UNITED STATES PATENT AND TRADEMARK OFFICE

APPLICATION NO.	FILING DATE	FIRST NAMED INVENTOR	ATTORNEY DOCKET NO.	CONFIRMATION NO.
10/710,254	06/29/2004	Carlo Gemme	22106-00067-US1	4253
30678	7590	09/29/2005	EXAMINER	
CONNOLLY BOVE LODGE & HUTZ LLP SUITE 800 1990 M STREET NW WASHINGTON, DC 20036-3425			BAUER, SCOTT ALLEN	
			ART UNIT	PAPER NUMBER
			2836

Office Action Summary	Application No. 10/710,254	Applicant(s) GEMME ET AL.	
	Examiner Scott Bauer	Art Unit 2836

DETAILED ACTION

FIG. 3

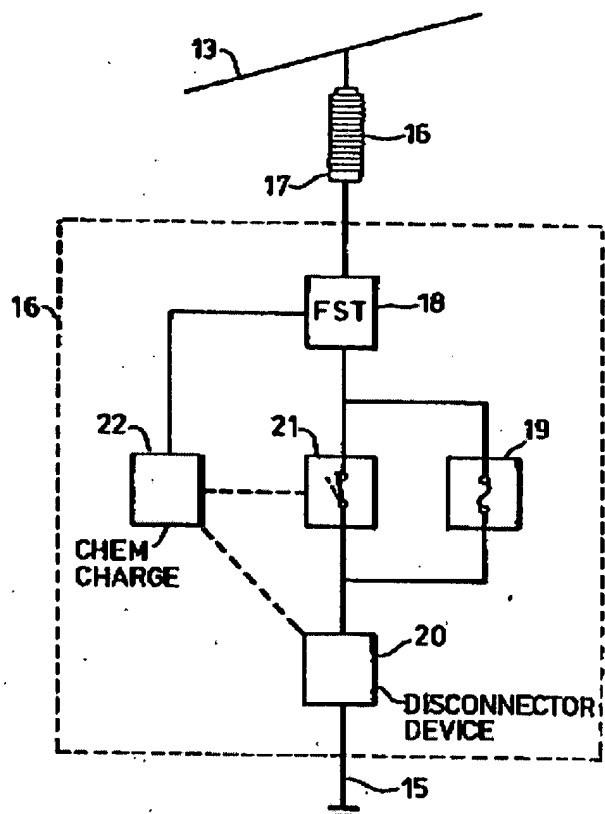
7. With regard to Claims 1,4, 6 & 11, Kortschinski, in figure 3, teaches a fault current limiting system (16), and a method of limiting fault current, comprising a switch (21), providing fast switching operation (column 2 lines 30-33), and a parallel current path comprising a limiting fuse (19).

12. With regard to Claim 1, a separate rejection is made, independent from the rejection of Claim 1 above. Kortschinski, in figure 3, teaches a fault current limiting system (16), comprising a switch (21), providing fast switching operation (column 2 lines 30-33), and a parallel current path comprising a limiting fuse (19).

Fig. 1

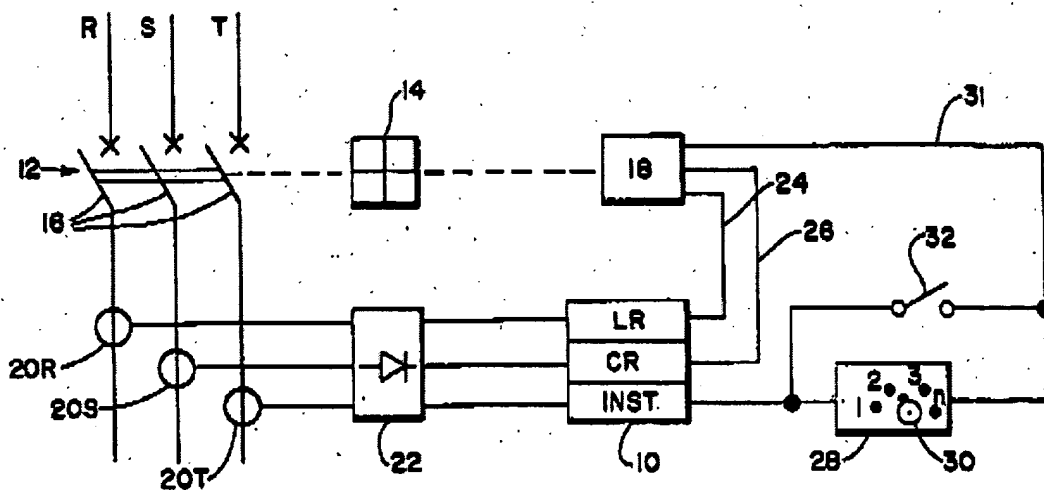
Puccinelli et al. in figure 1, further teaches a current limiting device comprising a reusable fast switch (12) and a solid-state control system (10), which automatically operates the switch to create a relatively high arc voltage (column 3 lines 1-19).

9. With regard to Claim 7, Puccinelli et al. discloses a fault current limiting system where a dedicated control (10) means for supervising protection logic (20 R, S&T) used in the fault current limiting system and operating at least one of the switching means (12) and for controlling the switching system. (column 3, lines 9-19 & 40-48).
